AIRWORTHINESS DIRECTIVE GLIDERS

GFA AD/144 BRASOV 2
Mandatory Bulletin IS-28B2/EO-7

PURPOSE OF AD:

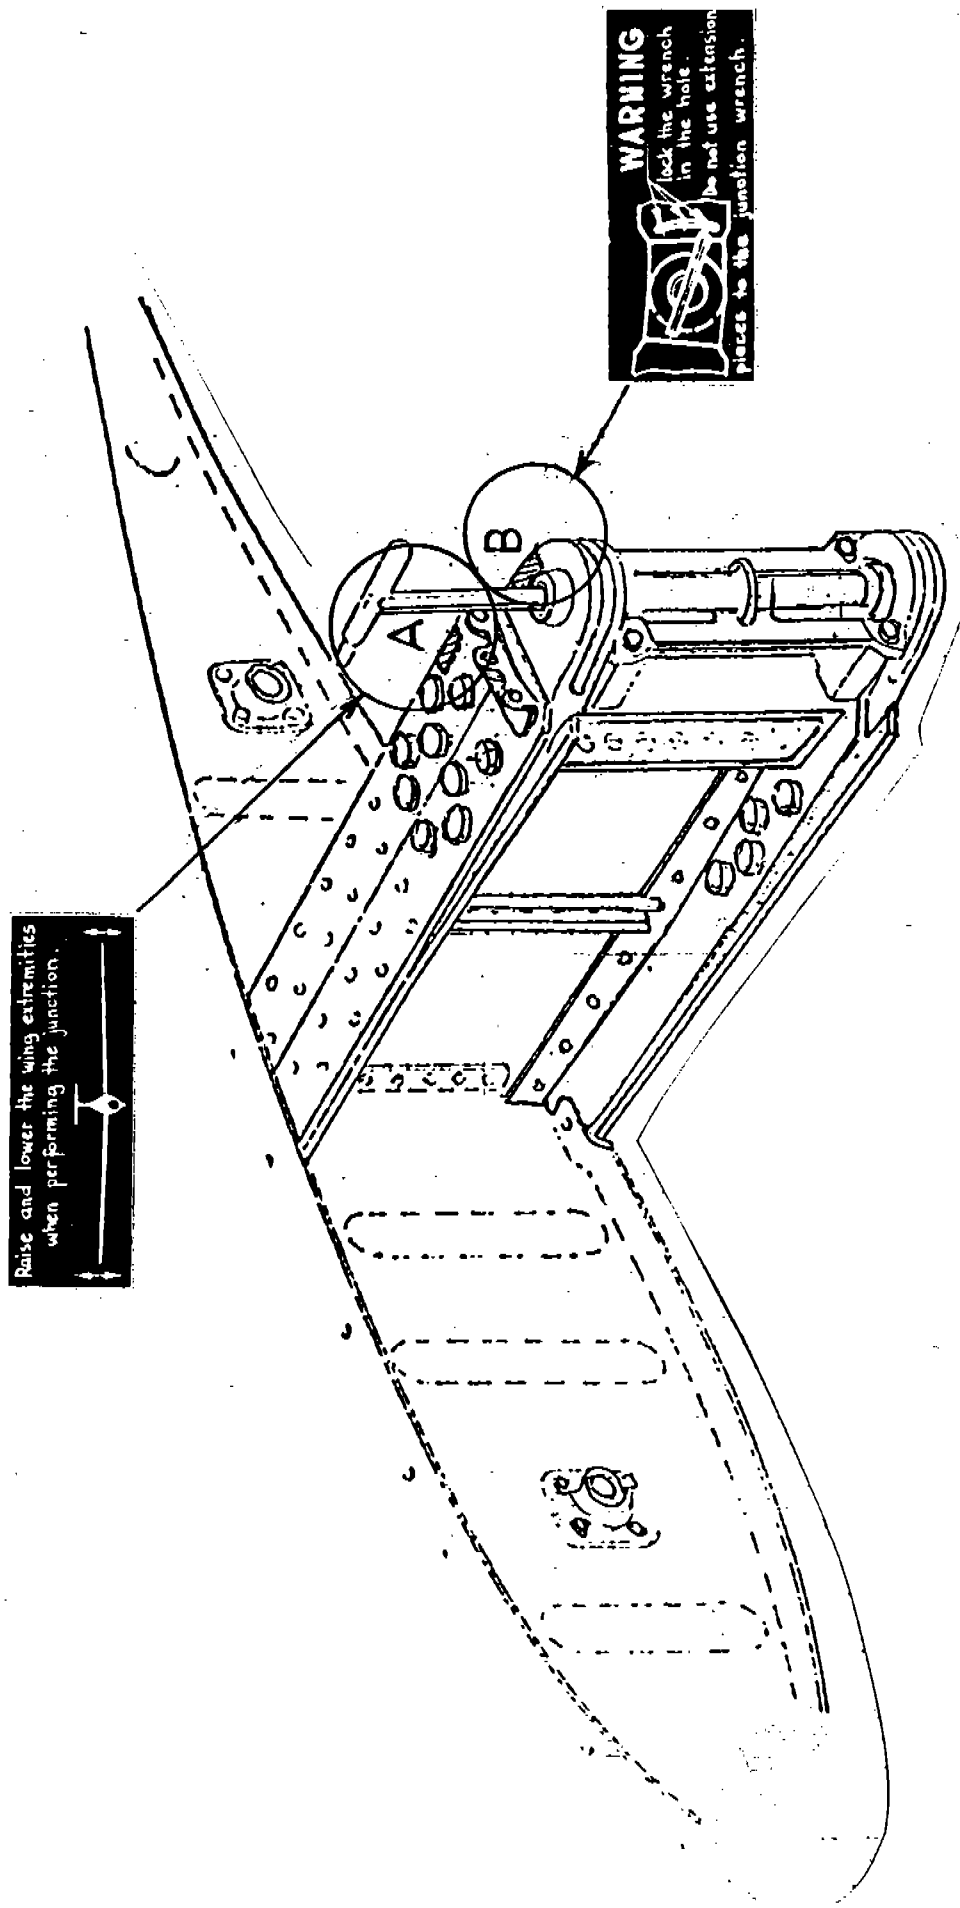
Clean the areas cross hatched at A and B on drawing attached to the AD with a soft cloth. Remove the protective skin on the placards and apply the labels in their respective locations indicated on drawing. Then firmly press the label with a soft cloth.

Fig. 6.2.1 Main junction tightening

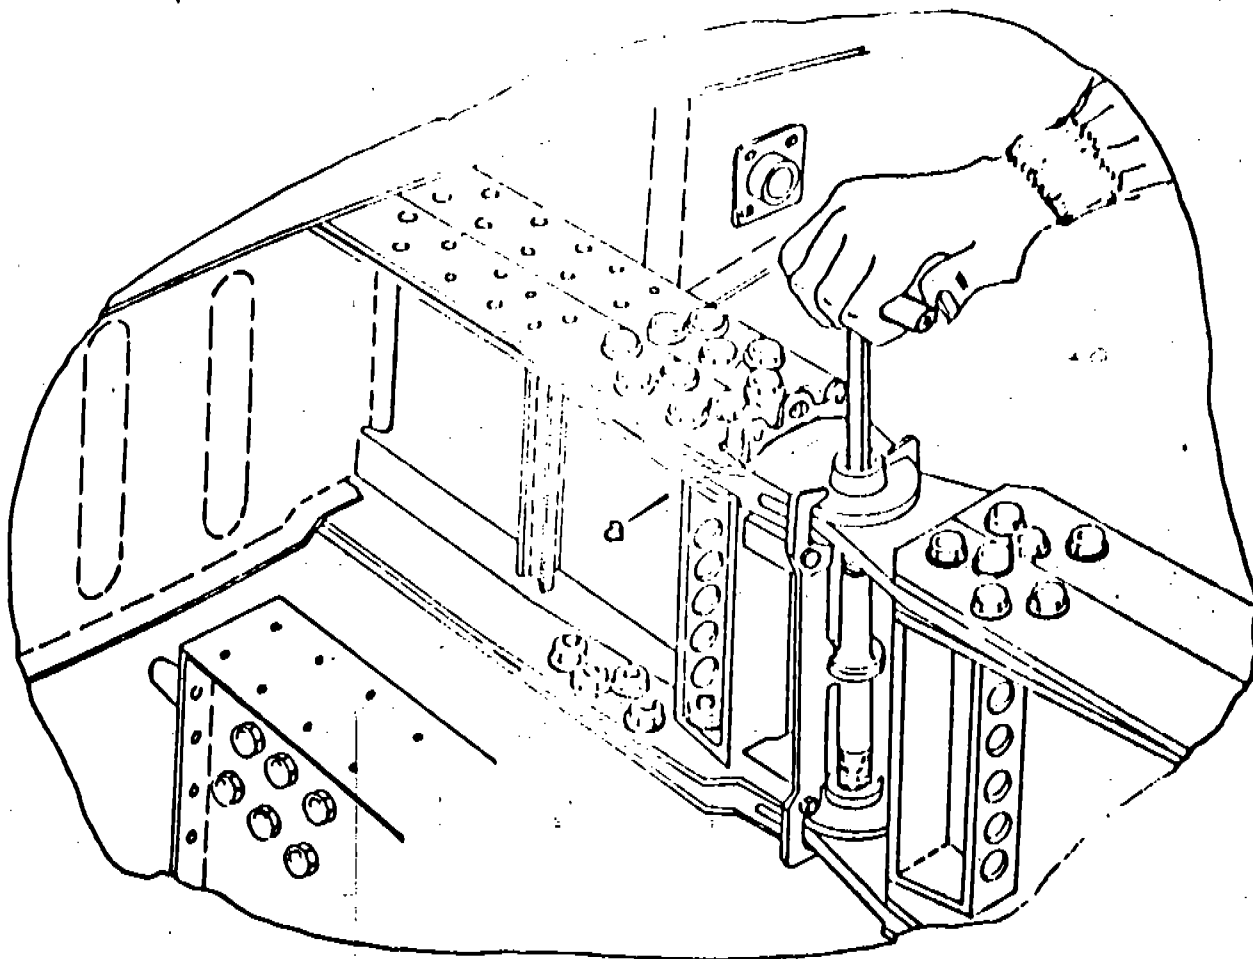
The junction wrench shall be actuated by hand only (without using extensions).

During the whole tightening operation two persons shall raise and lower the wing extremities simultaneously to facilitate the cones lead in.

Match the wrench into one of the three locking holes indicated by "a" by removing, twisting and inserting it, until the correct position is found (sometimes a slight tightening is also required).
